PERFORMANCE BULLETIN 130

NXT Transformer Substitution

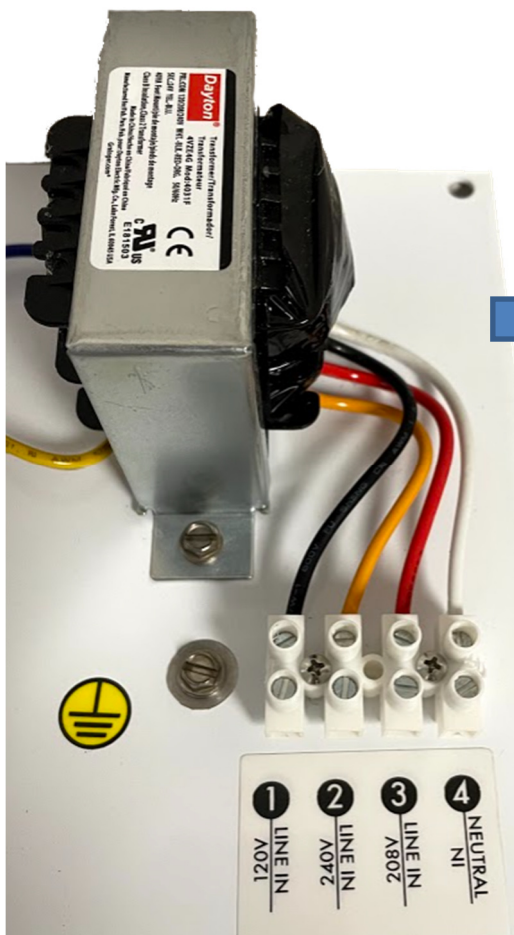
Due to supply shortage on the NXT transformer PN 4510157, AQ Matic will temporarily substitute a different transformer on NXT orders. The substitute transformer is Triad PN TCT40-05E07K and is UL, and cUL approved.

Installation wiring remains unchanged for 120VAC installations. When connecting to 208VAC or 240VAC input voltage, wiring is updated as shown below and on label within the control.

Original Transformer PN 4510157

Substitute Transformer PN 4510157
